ADDENDUM NO. 1

Date: October 11, 2024

Project: DPW PROJECT NO. 25110 – **Design Professional RFQ**

2 FLOOR PLAN - COTTAGE #2
Scale: 1/8" = 1'-0"

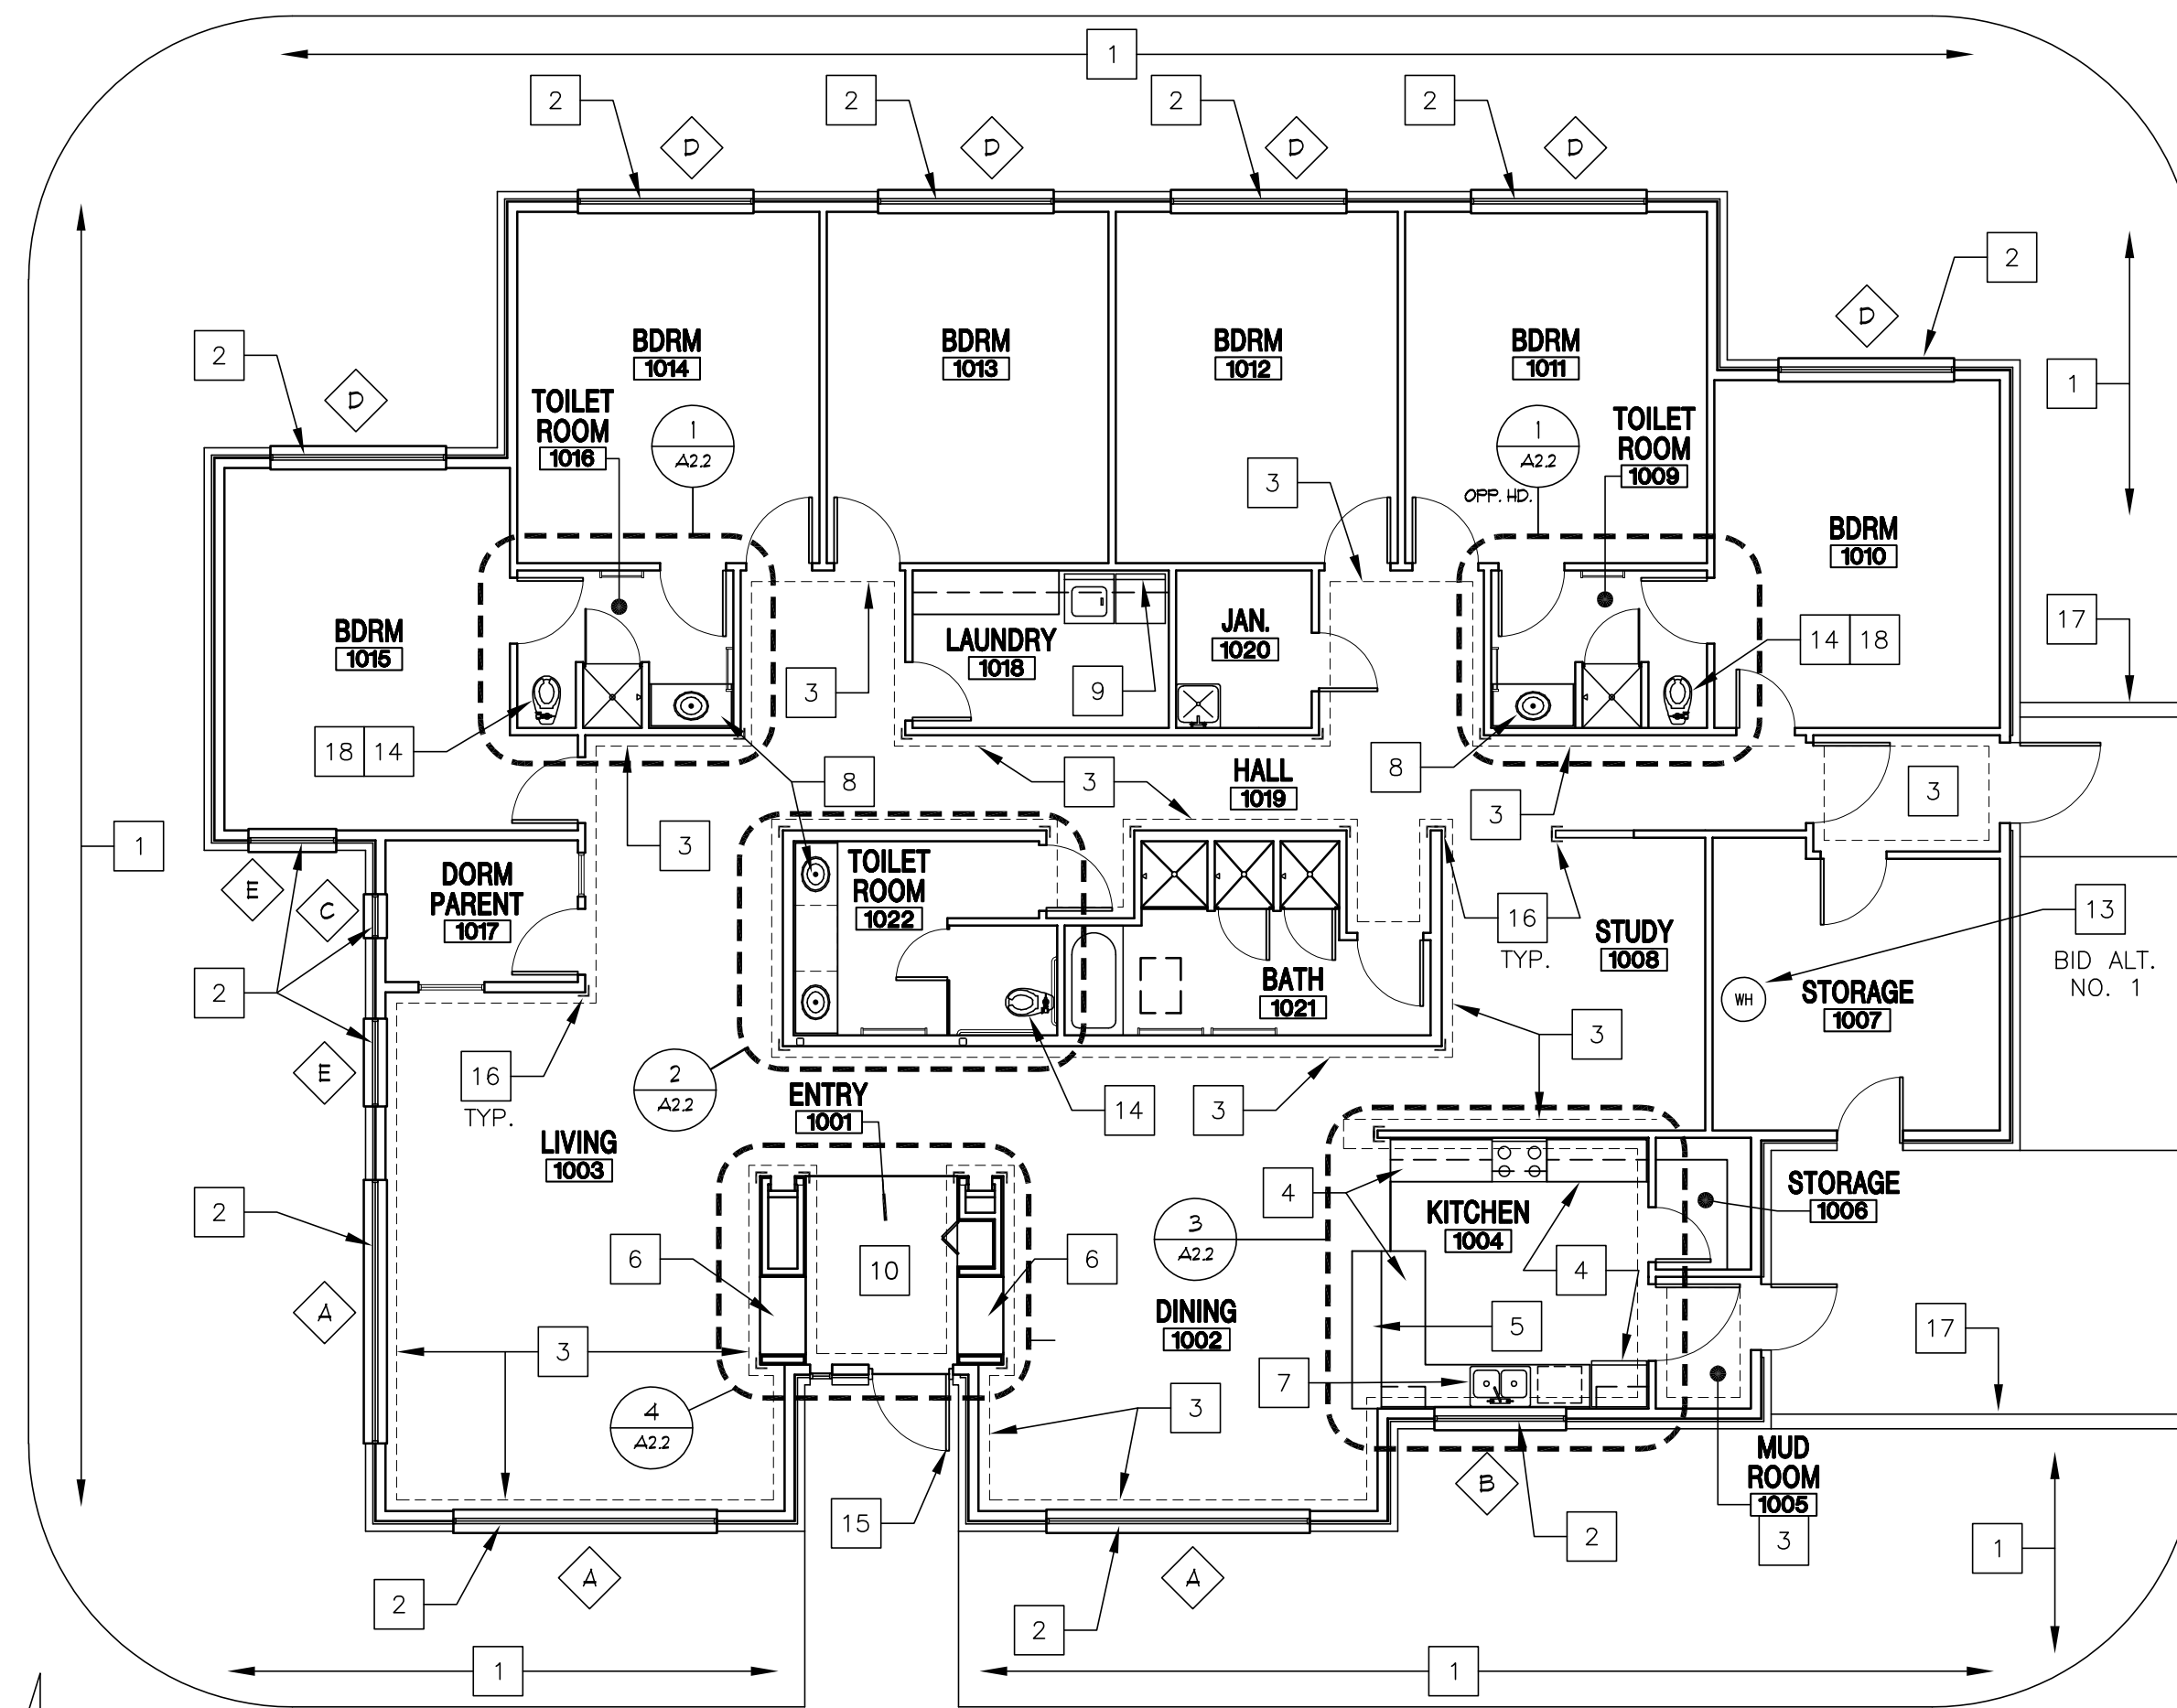
Question #1: Are existing drawings of the other cottages available to be shared?

Answer #1: Yes. See attached.

The new cottages are not anticipated to match the existing floor plans.
